# Memorandum

**TO:** Columbia River Crossing Task Force  
**FROM:** CRC Pedestrian and Bicycle Advisory Committee (PBAC)  
**SUBJECT:** PBAC Recommendations for World Class Pedestrian and Bicycle Facilities

# PBAC Proposed Pedestrian and Bicycle System for Replacement Bridge

# Pedestrian and Bicycle Advisory Committee Recommended Pathway on West Side of West Replacement Bridge (Looking North)

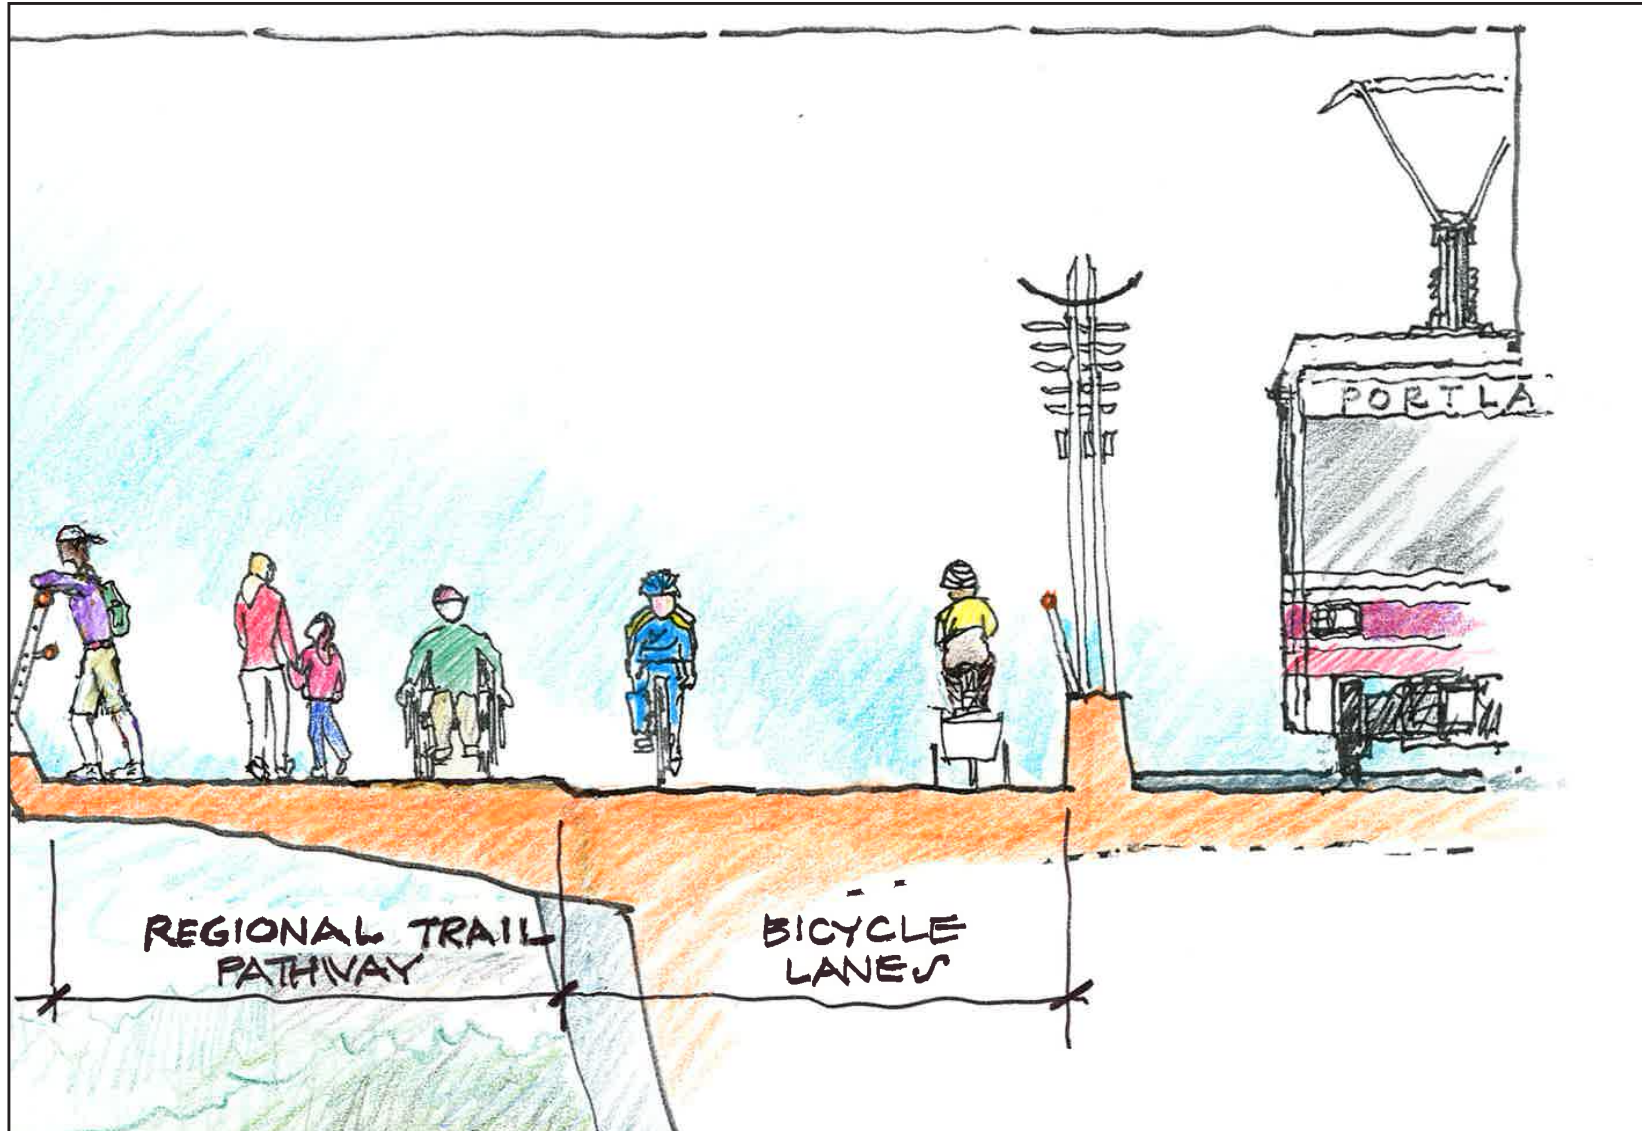
- The overall pathway on the western bridge (adjacent to the transit guideway) must provide separation between recreational users and higher speed bicycle users. To provide this separation, a 12-foot wide regional trail should be provided adjacent to, and to the west of, a pair of six-foot wide bicycle lanes (see attached rendering). These recommended widths are exclusive of potentially needed shy distances, i.e., free and clear of poles and other obstructions to enable safe pedestrian and bicycle movement (a summary of agency standards for multiuse paths, sidewalks and bike lanes is attached).

The regional trail would accommodate pedestrians, persons with disabilities, seniors, families with children, tourists, roller-skaters, and recreational bicycle riders. The adjacent bicycle lanes would be used by bicycle commuters and other faster-moving bicyclists. The regional trail would be at a slightly higher level than the bicycle lanes, but bicyclists in the bicycle lanes would be able to access the trail. Different paving treatments and/or patterns should differentiate the regional trail and the bicycle lanes.
